[Docket No. 2001-SW-13-AD]

Airworthiness Directives; Bell Helicopter Textron, Inc. Model 47B, 47B-3, 47D, 47D-1, 47G, 47G-2, 47G2A, 47G-2A-1, 47G-3, 47G-3B, 47G-3B-1, 47G-3B-2, 47G-3B-2A, 47G-4, 47G-4A, 47G-5, 47G-5A, 47H-1, 47J, 47J-2, 47J-2A, and 47K Helicopters

ACTION: Notice of proposed rulemaking.

Figure 1, Appendix 1

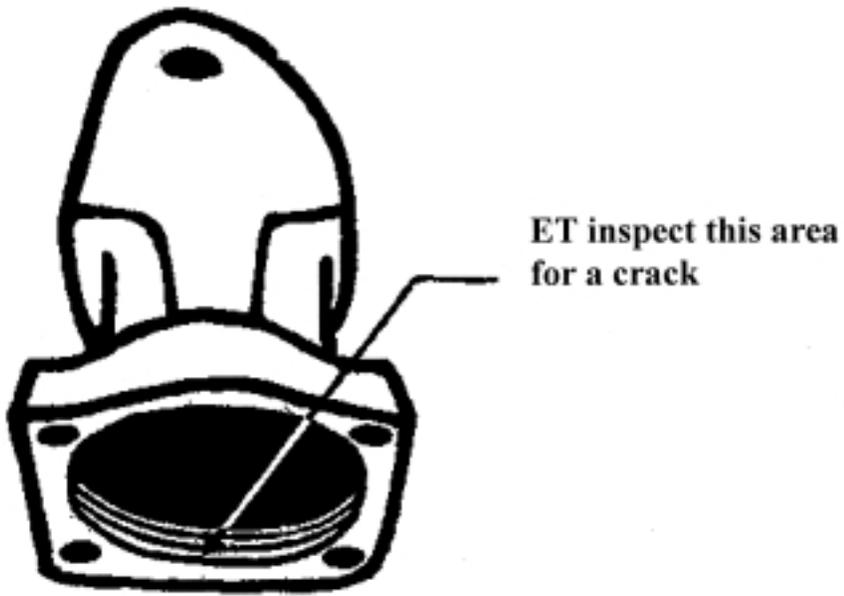
1.1 The inboard inside diameter machined threads (reference figure 1).

Figure 2, Appendix 1

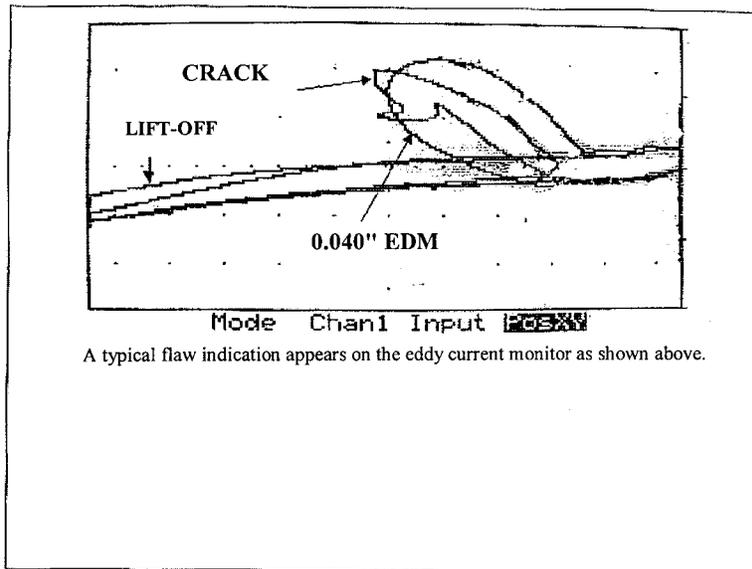
6.1 Place the probe into the threaded area and slide it in the same direction as was done on the standard while monitoring the screen for root cracks. Moving the probe in the same direction produces a repeatable display that allows for more accurate flaw size determination. Scan the probe along each individual thread until all the threads are inspected. (See Figures 2 and 3.)

Figure 3, Appendix 1

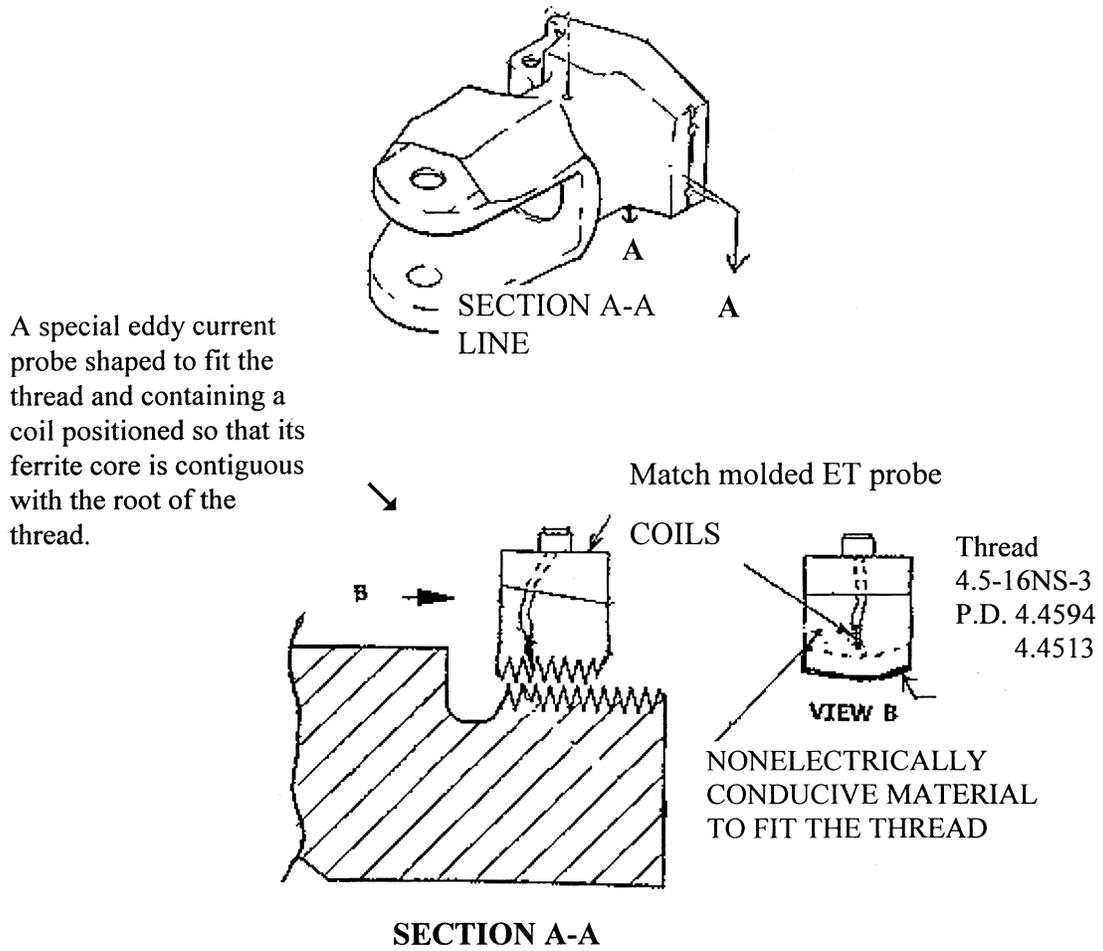
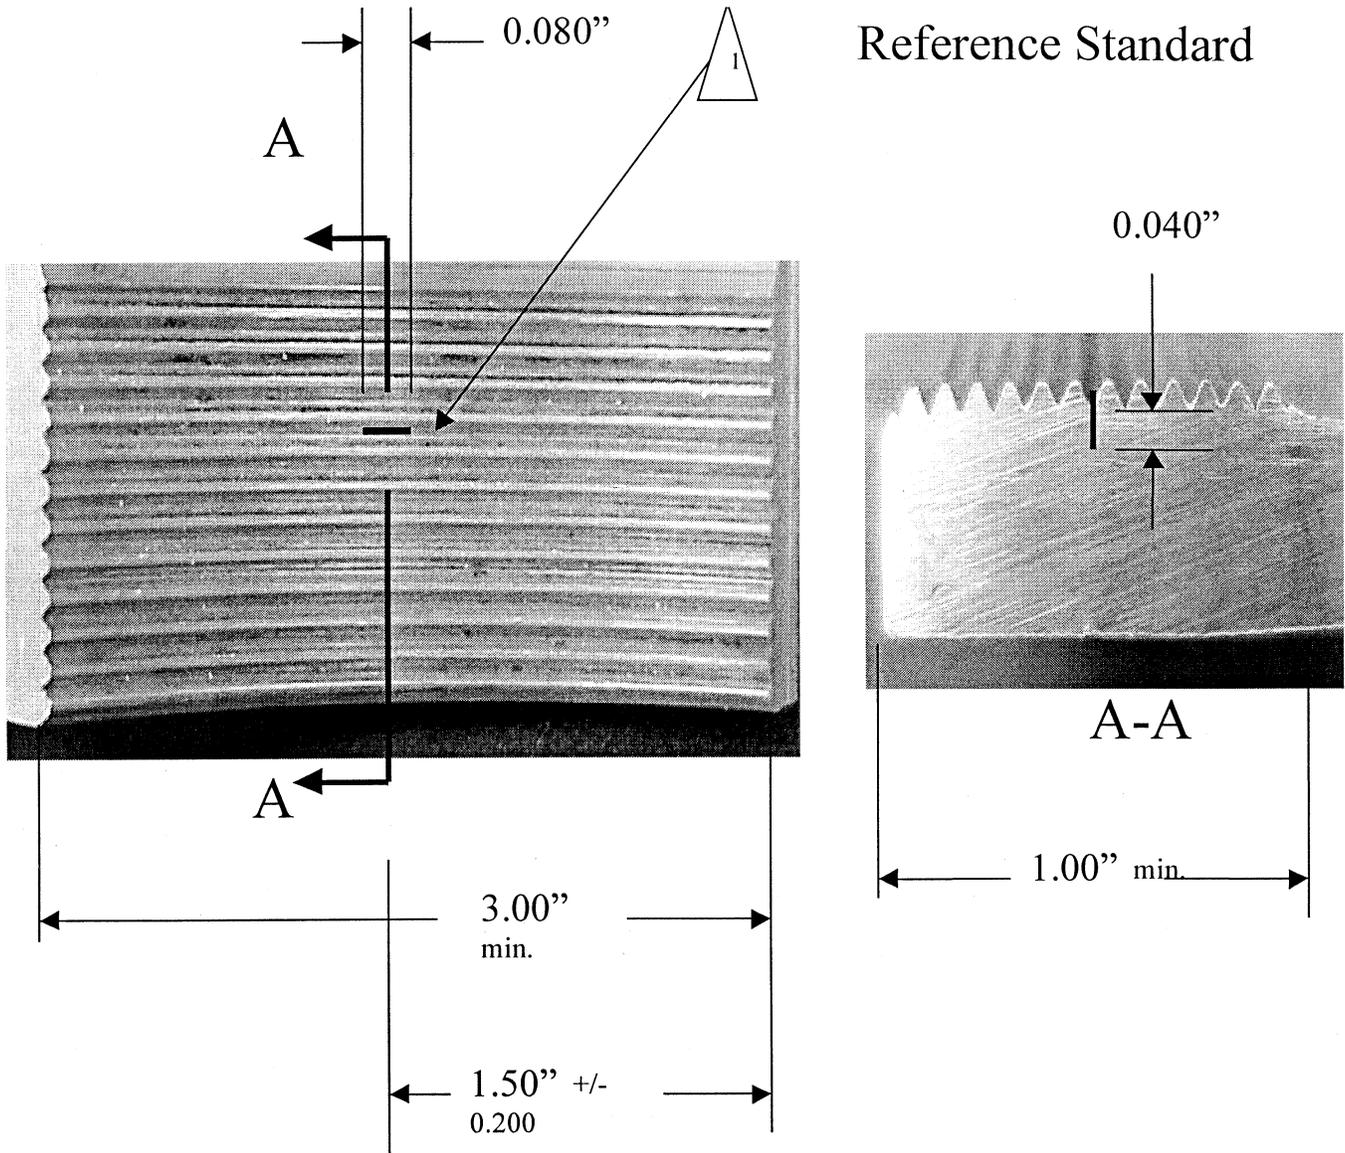
2.2 Match molded ET probe SPC-193 (100kHz) or equivalent. (See Figure 3.)
